# Harbour Energy Closing Statement to Morgan DCO Examination

Figure 2: Millom East Buffer Zones (from Appendix A of REP6-006)

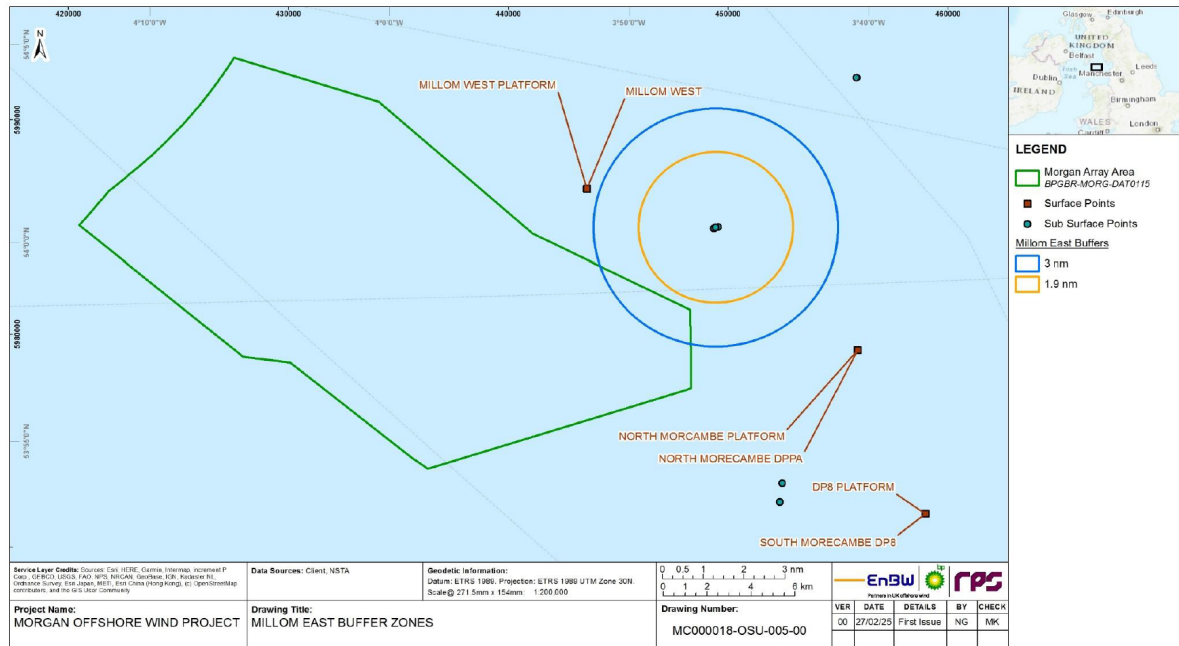
Figure A.1 in Appendix A of Annex 3.2 to the Applicant's response to Harbour Energy's submission at Deadline 5 (REP6-xxx) (reproduced as Figure 2 below), shows a very small spatial overlap between the proposed Morgan Array Area and a circle of radius 3nm around the Millom East pipeline end manifold (PLEM). Based on the Applicant's updated project description in REP6-024, the minimum separation between wind turbine generators is proposed to be 1400m (Section 3.5.6.2 of REP6-024). On this basis, a maximum of two of the up to 96 (see Table 3.1 in Section 3.3.3 of REP6-024) wind turbine generators could be positioned within this area of overlap.

By contrast, the placing of any wind turbine generator within 3nm of the helideck of a non-producing installation (NPI) at the Millom East PLEM (which could be up to 100m closer to the Morgan Generation Assets than the centre of the PLEM, depending on the actual location of the NPI and the position of its helideck) would, as a result of the rules agreed by helicopter operators with the CAA, restrict flights to daylight and visual. As further discussed in section 4.1 below, the impact of this would be that Harbour Energy’s decommissioning programme, currently anticipated to last for a contiguous period of 120 days (and not as erroneously stated by the Applicant in section 6.2.1.4 of REP6-014, “120 days split through a number of years”), would be likely to be extended by between 23 and 39 days (about a 25% to 30% increase) and would result in additional costs likely to be in excess of £10 million. Harbour Energy considers both this level of disruption and economic loss to be material.
